PROPOSED ANIMAL CONTROL FACILITY

**TOWN OF STRATFORD
BEACON POINT ROAD
STRATFORD, CT 06614
BID #2009-064**

S/P+A PROJECT NO. 06.196

DATE: August 25, 2009

PHONE & DATA NETWORK SCHEMATIC

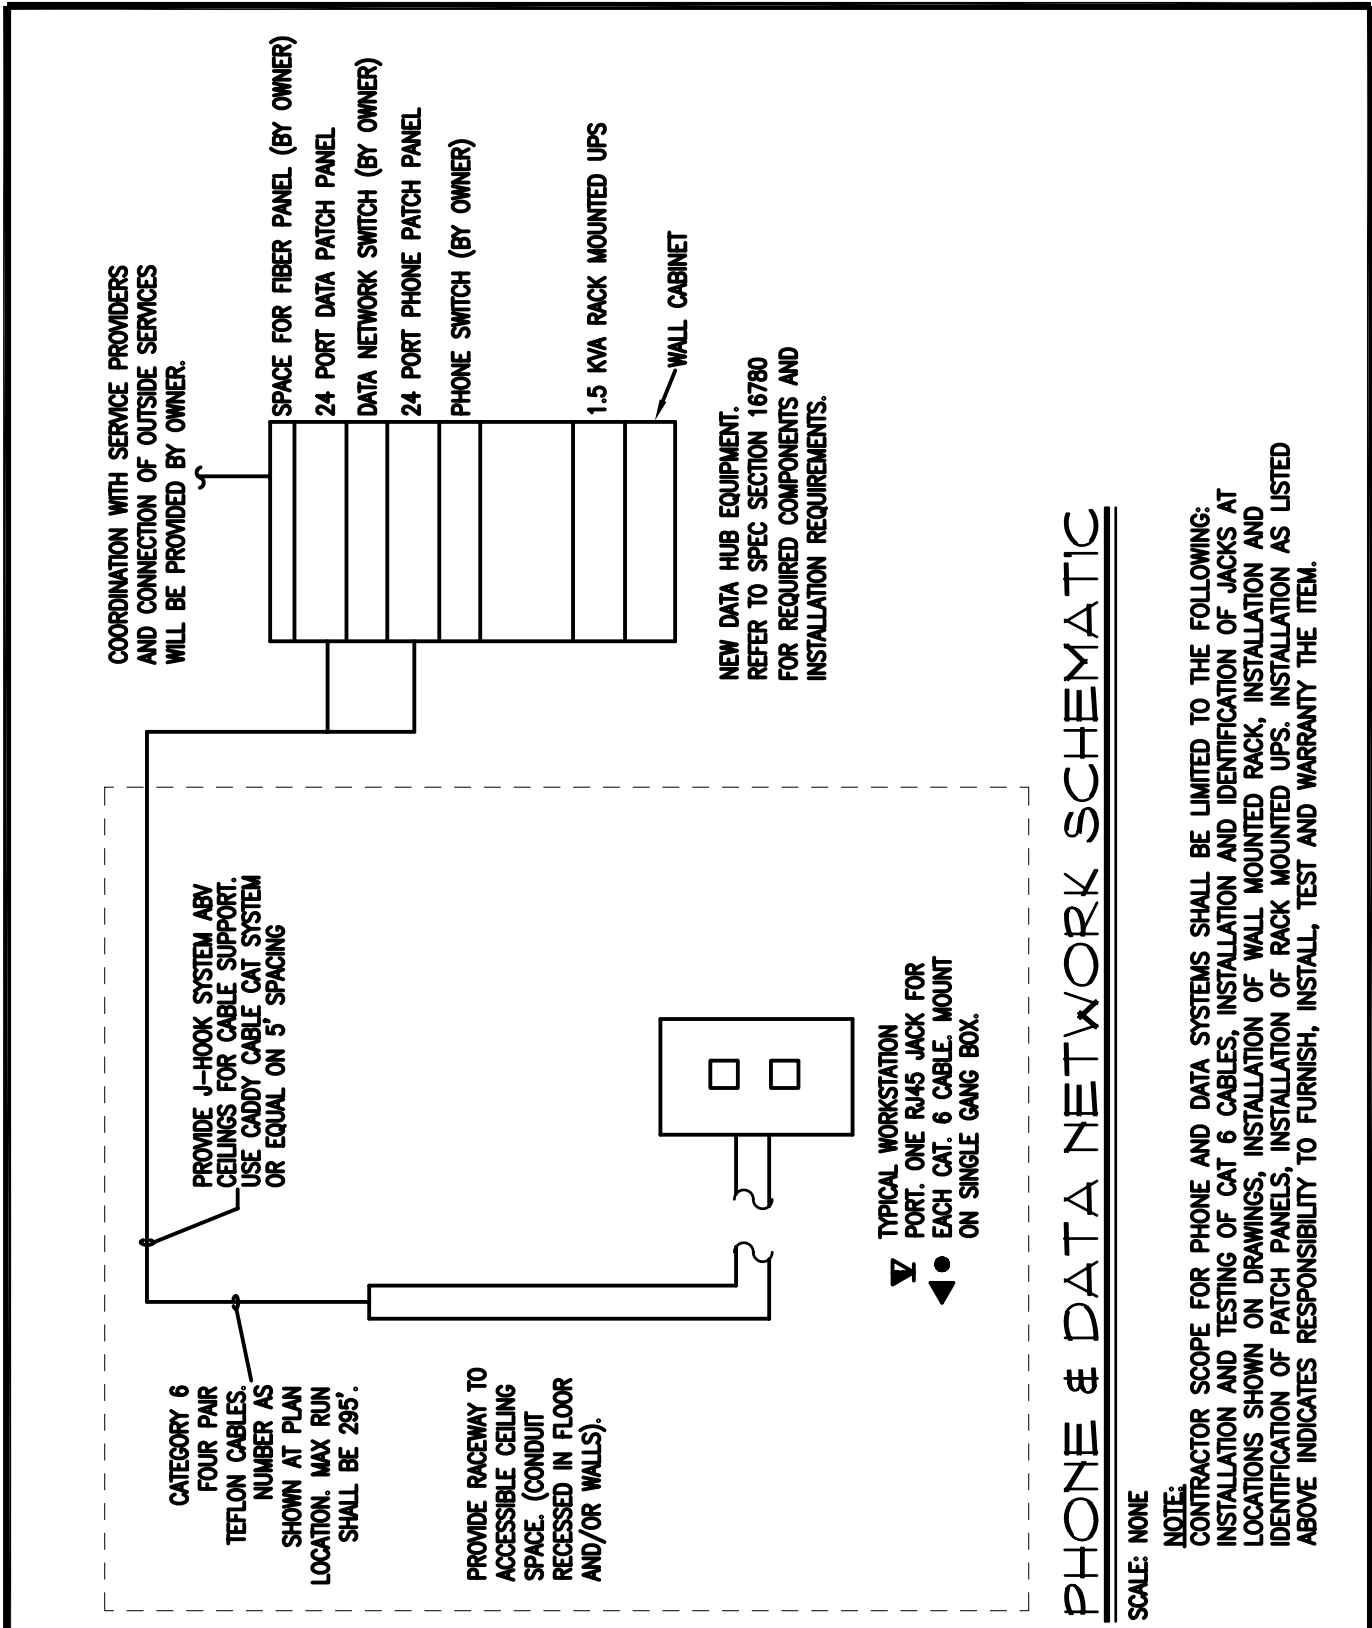
DRAWING SK-E1, PHONE & DATA NETWORK SCHEMATIC, has been added and is attached as part of this addendum. This is additional information for Drawing E6.

CONTRACTOR SCOPE FOR PHONE AND DATA SYSTEMS SHALL BE LIMITED TO THE FOLLOWING: INSTALLATION AND TESTING OF CAT 6 CABLES, INSTALLATION AND IDENTIFICATION OF JACKS AT LOCATIONS SHOWN ON DRAWINGS, INSTALLATION OF WALL MOUNTED RACK, INSTALLATION AND IDENTIFICATION OF PATCH PANELS, INSTALLATION OF RACK MOUNTED UPS. INSTALLATION AS LISTED ABOVE INDICATES RESPONSIBILITY TO FURNISH, INSTALL, TEST AND WARRANTY THE ITEM.
